SUBDIVISION REVIEW SHEET**CASE NO.:** C8-2019-0114.1A**PC DATE:** July 28, 2020**SUBDIVISION NAME:** Simon-Caskey Final Plat**AREA:** 16.664 ac.**LOT(S):** 26**OWNER:** Stephen Simon**AGENT/APPLICANT:** Bill E. Couch (Carlson, Brigrance & Doering, Inc.)**ADDRESS OF SUBDIVISION:** 7715 W SH 71 **COUNTY:** Travis**WATERSHED:** Williamson Creek**EXISTING ZONING:** SF-1, SF-2-NP, SF-6-NP**PROPOSED LAND USE:** Multifamily & Commercial with ROW and Parkland

CITY OF AUSTIN –DEVELOPMENT SERVICES DEPARTMENT
SUBDIVISION APPLICATION – MASTER COMMENT REPORT

CASE NUMBER: C8-2019-0114.1A
UPDATE: U0
CASE MANAGER: Joey de la Garza PHONE #: 512-974-2664

PROJECT NAME: Simon-Caskey Final Plat
LOCATION: 7715 W SH 71

SHEET NO. 1 OF 2

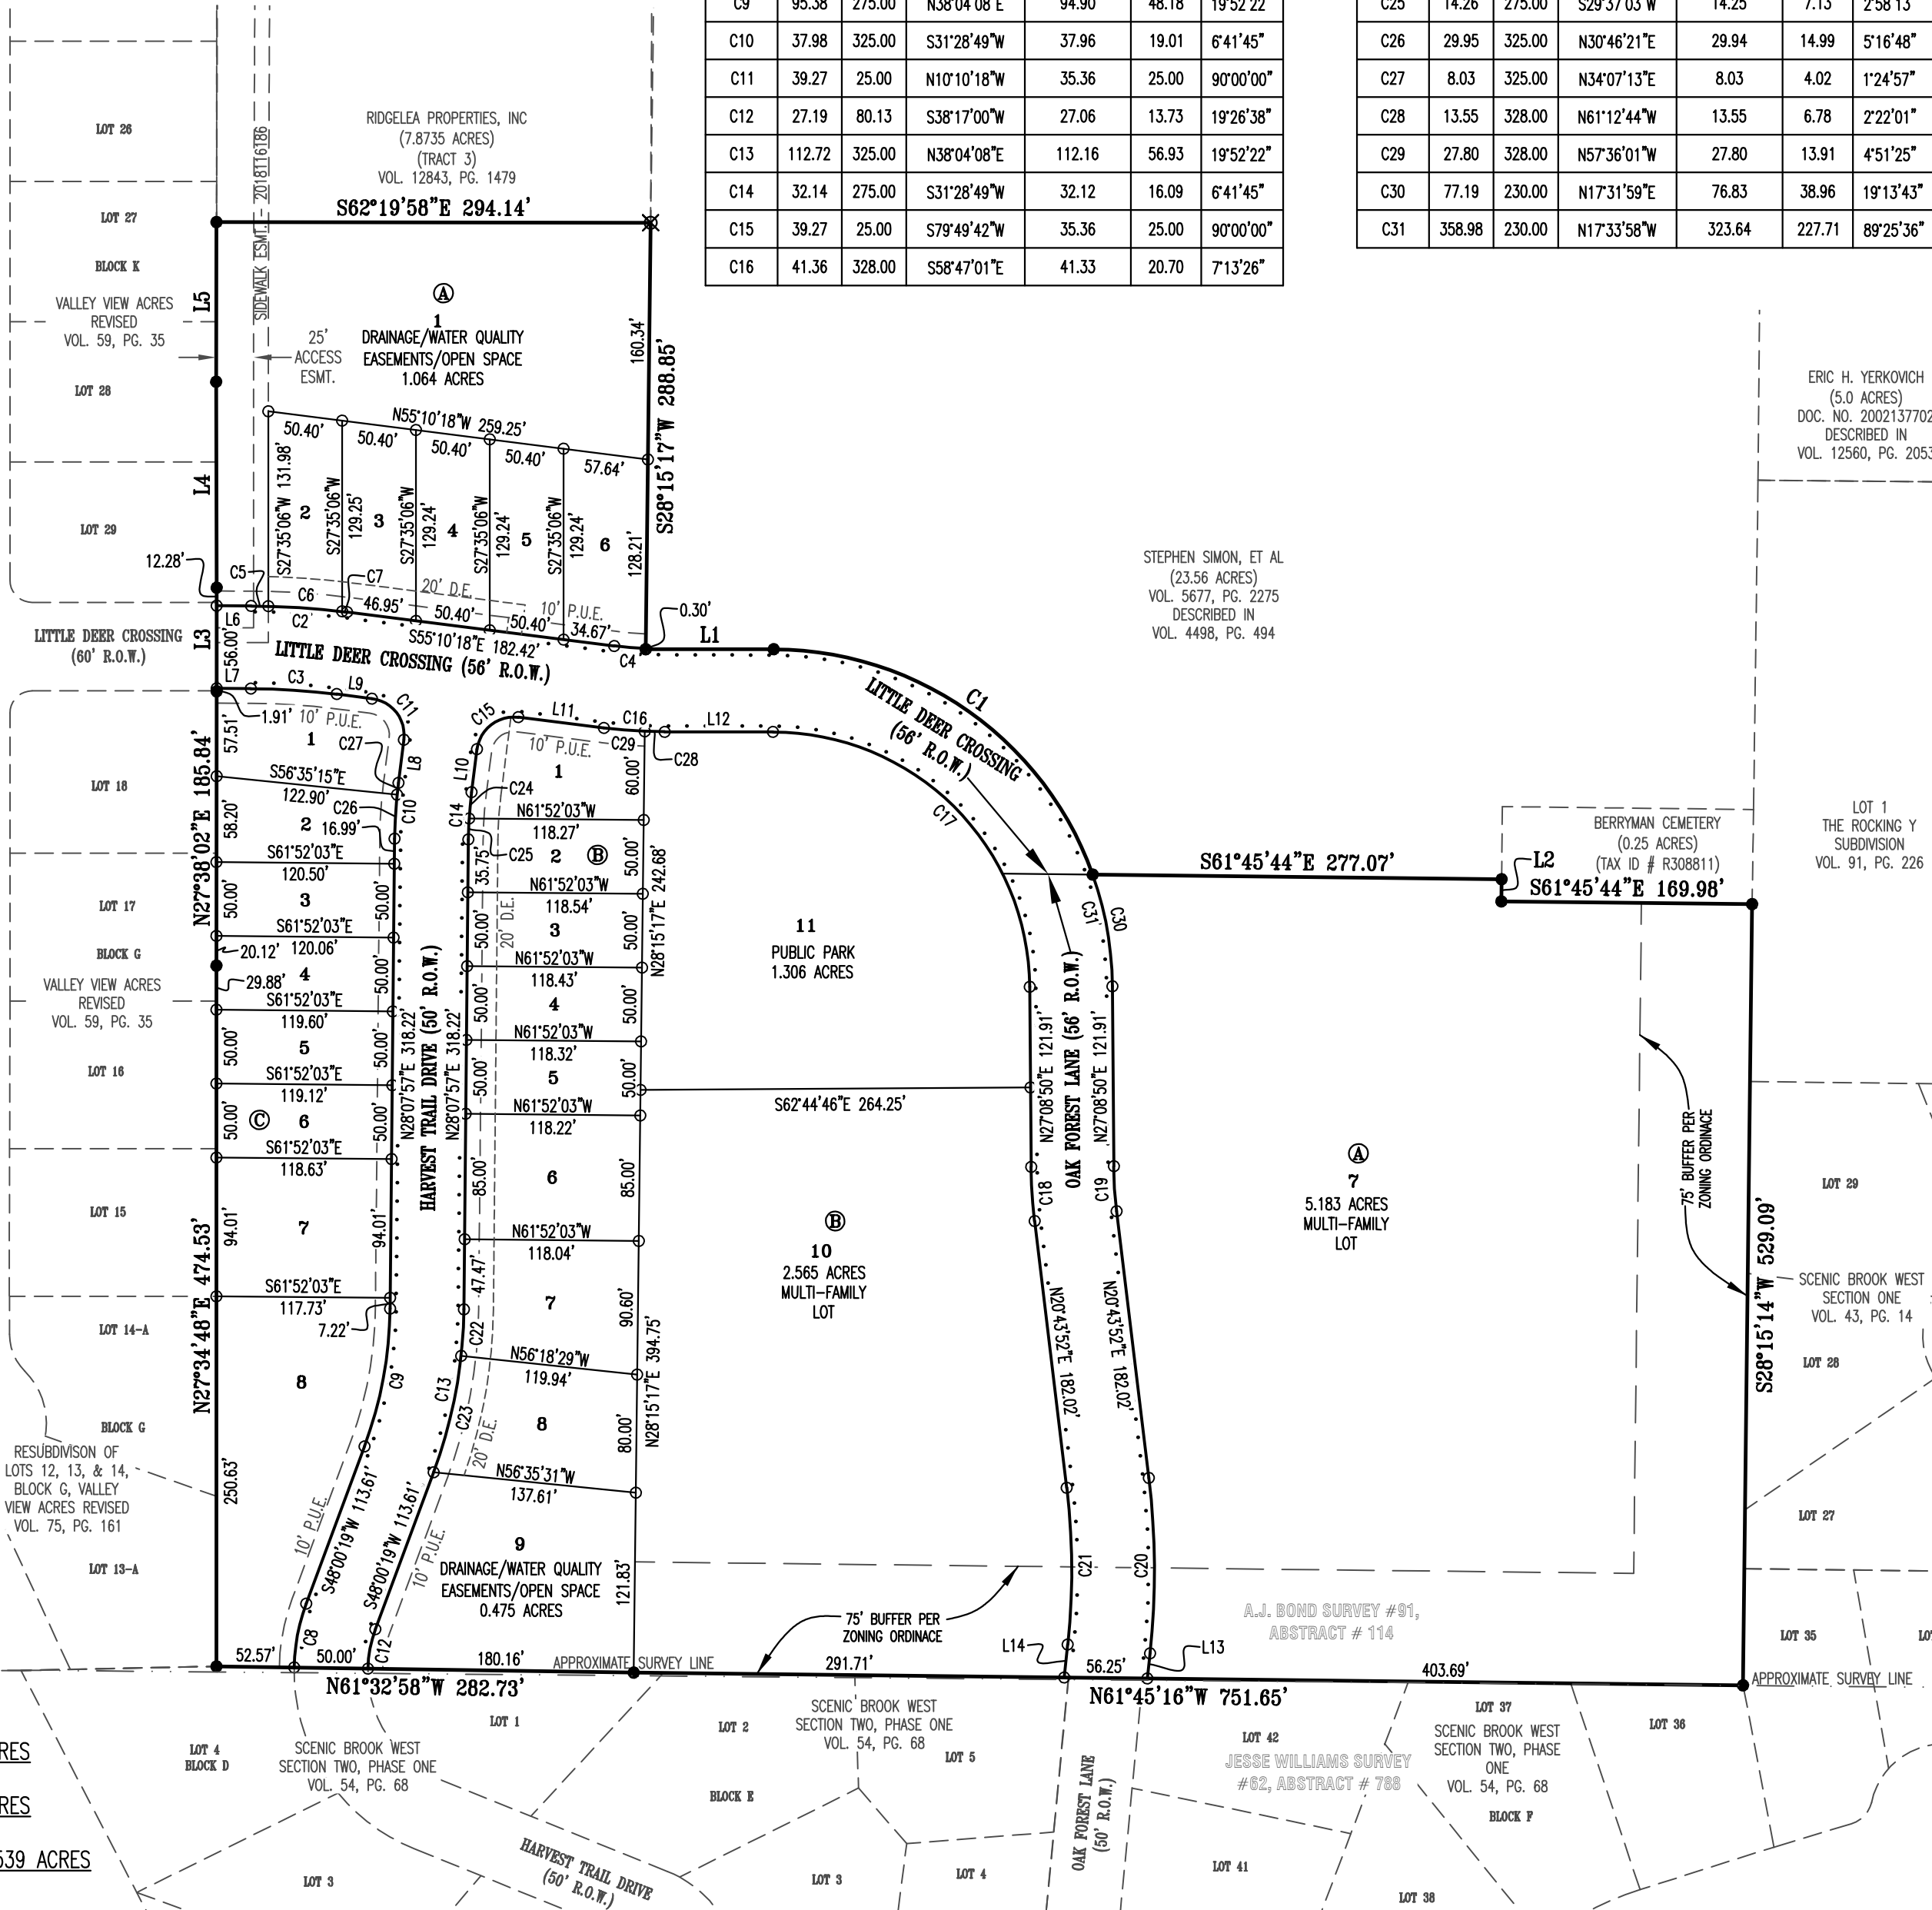
- SR 6. On sheet 1 of plat, total acreage for Multi-Family is listed as 9.054 acres and it seems the parkland acreage was included in this total. Please correct the total acreage for Multi-Family to 7.748 acres. (*City of Austin LDC; 25-1-83*)
- SR 7. Provide documentation that <name>, <title>, has the authority to sign the plat as owner on behalf of Ridgelea Properties, Inc. (*City of Austin LDC; 25-1-83*)
- SR 8. Original (crimped) tax certificates showing all taxes having been paid for the past year must be provided at the time the plat is cleared for approval. These tax certificates are available from the Travis County Tax Office at 5501 Airport Boulevard and must be ordered two (2) days prior to receipt. Tax receipts or other information in-lieu of certificates cannot be substituted. Travis County will NOT record the plat without them. (*City of Austin LDC; 25-1-83*)

EL 1. Ten/Fifteen foot electric distribution, electric telecommunications, and electric fiber easement is required adjacent to all street R.O.W. Please dedicate ETE or continue PUE down Little Deer Crossing/Oak Forest Lane.
